**FEMA Levee Certification
Ventura County, California**

**Ventura River Levee and Floodwall (VR-3)
At Live Oaks**

**Evaluation Report
February 13, 2009**

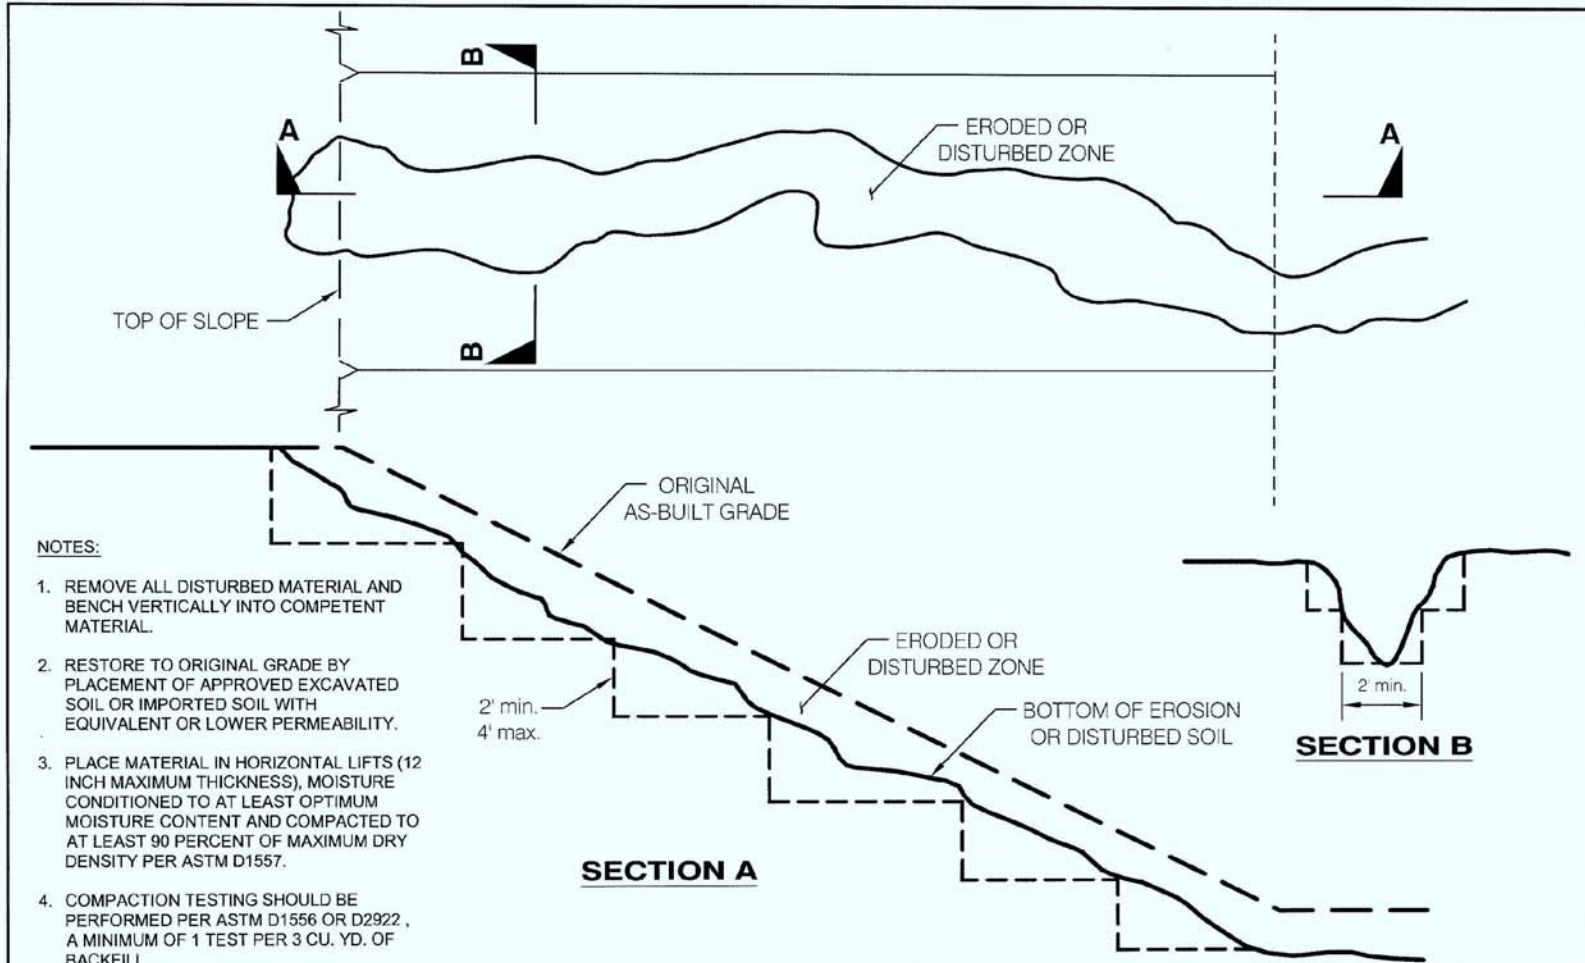
<p>4. Can Tetra Tech provide specs for compaction and grading requirements? Discuss major and minor repair examples.</p>	<p>Compaction requirements are detailed on the attached Figures 1 and 2. Major repair examples include any erosion feature that is deeper than 1 foot or that is greater than 2 feet wide. Major and minor animal burrows are discussed in item 1.</p>
<p>5. Can in-kind materials be used for backfill?</p>	<p>In-kind backfill would be materials free of organic or deleterious debris that has similar or lower permeability than the levee material. These materials could consist of excavated soil, imported soil, concrete, or slurry, and shall be evaluated by the testing and materials lab.</p>
<p>6. Discuss documentation/inspection requirements for verification of grading.</p>	<p>The requirements for verification of grading are discussed above.</p>

1. REMOVE ALL DISTURBED MATERIAL AND BENCH VERTICALLY INTO COMPETENT MATERIAL.
2. RESTORE TO ORIGINAL GRADE BY PLACEMENT OF APPROVED EXCAVATED SOIL OR IMPORTED SOIL WITH EQUIVALENT OR LOWER PERMEABILITY.
3. PLACE MATERIAL IN HORIZONTAL LIFTS (12 INCH MAXIMUM THICKNESS), MOISTURE CONDITIONED TO AT LEAST OPTIMUM MOISTURE CONTENT AND COMPACTED TO AT LEAST 90 PERCENT OF MAXIMUM DRY DENSITY PER ASTM D1557.
4. COMPACTION TESTING SHOULD BE PERFORMED PER ASTM D1556 OR D2922, A MINIMUM OF 1 TEST PER 3 CU. YD. OF BACKFILL.

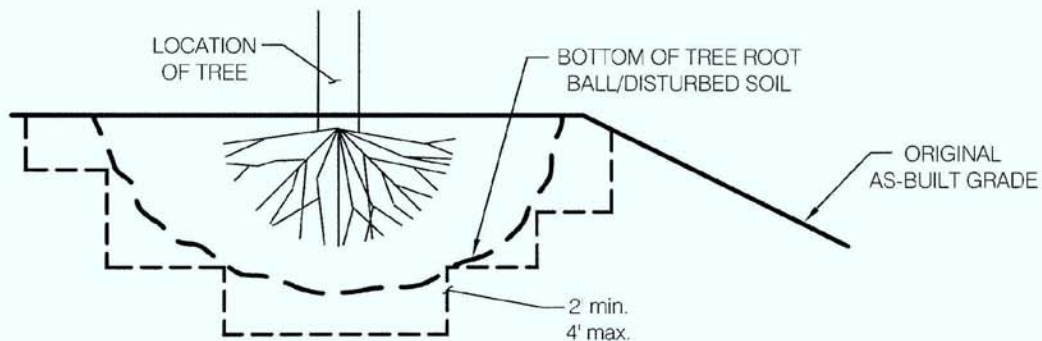
<p>2. Please describe methods for vegetation and rootball removal.</p>	<p>4" DIAMETER TRUNK OR GREATER: Cut the woody vegetation approximately two (2) feet above ground level leaving a prominent stump for use in the rootball extraction process. Remove the stump and rootball by pulling or extracting with a backhoe or similar equipment. Clean the rootball cavity of all loose soil and remaining root system (roots greater than 1/2" diameter). Prepare the cavity by excavating per FIGURE 2. Backfill with excavated soil or imported soil with equivalent or lower permeability. Place material in horizontal lifts no greater than twelve (12) inches. Moisture conditioned to at least optimum moisture content and compacted to at least ninety (90) percent of the maximum dry density of the fill soil per ASTM D1557. Compaction typically requires the use of manually operated compaction equipment or compaction attachment to a backhoe. Compaction testing should be performed per ASTM D1556 or D2922. A minimum of one (1) test per three (3) cubic yards of backfill.</p> <p>2"-4" DIAMETER TRUNK: Cut the woody vegetation stump flush with the ground. Treat the stump with a protective coating similar to polyurethane to prolong the decay process.</p>

1. REMOVE ALL DISTURBED MATERIAL AND BENCH VERTICALLY INTO COMPETENT MATERIAL.
2. RESTORE TO ORIGINAL GRADE BY PLACEMENT OF APPROVED EXCAVATED SOIL OR IMPORTED SOIL WITH EQUIVALENT OR LOWER PERMEABILITY.
3. PLACE MATERIAL IN HORIZONTAL LIFTS (12 INCH MAXIMUM THICKNESS), MOISTURE CONDITIONED TO AT LEAST OPTIMUM MOISTURE CONTENT AND COMPACTED TO AT LEAST 90 PERCENT OF MAXIMUM DRY DENSITY PER ASTM D1557.
4. COMPACTION TESTING SHOULD BE PERFORMED PER ASTM D1556 OR D2922, A MINIMUM OF 1 TEST PER 3 CU. YD. OF BACKFILL.
